Passive House Feasibility Study

1149-1151 Walnut Street, Newton Massachusetts

Prepared for:

July 22, 2020

Example A:

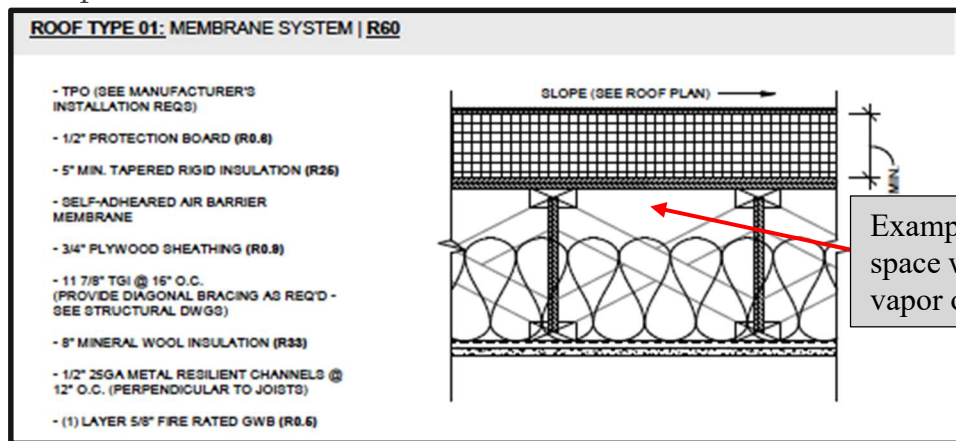
No Roof example was given so we estimated the baseline roof at R-35. For meeting Passive House, The roof assembly should be designed with a minimum total R-value of R-60. Roof deck recommendation would be several layers of poly-iso **OR** XPS insulation followed by additional insulation below the deck. If vapor open insulation is used below the roof deck, there must be no open airspace between the roof deck and the interior insulation. (See Example A image below)

Our recommendation for reducing condensation potential is one of the following options:

1. Fill entire space below roof deck with blown-in insulation.

2. Use closed cell spray foam to fill the space below the roof deck equivalent to an R-40 or better (dependent on thickness of exterior foam).

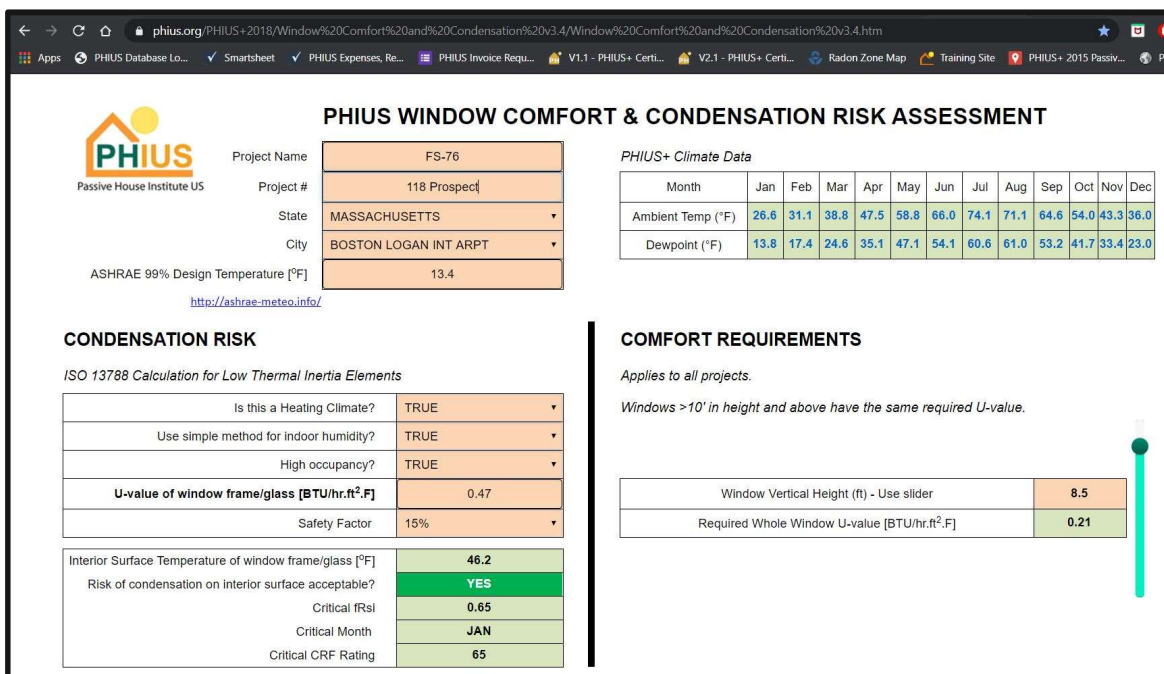
2. The large east facing window, should be either broken into several smaller windows, or removed entirely. Tall windows in Passive House projects are difficult as there are rigorous comfort and condensations requirements. For the purpose of this feasibility study, this window was removed.
3. Reducing the window/wall area ratio will also aid in meeting the Passive House standard.
Recommendation: Reduce quantity of windows.

- d. Remove entirely or break up the large window on the East façade.
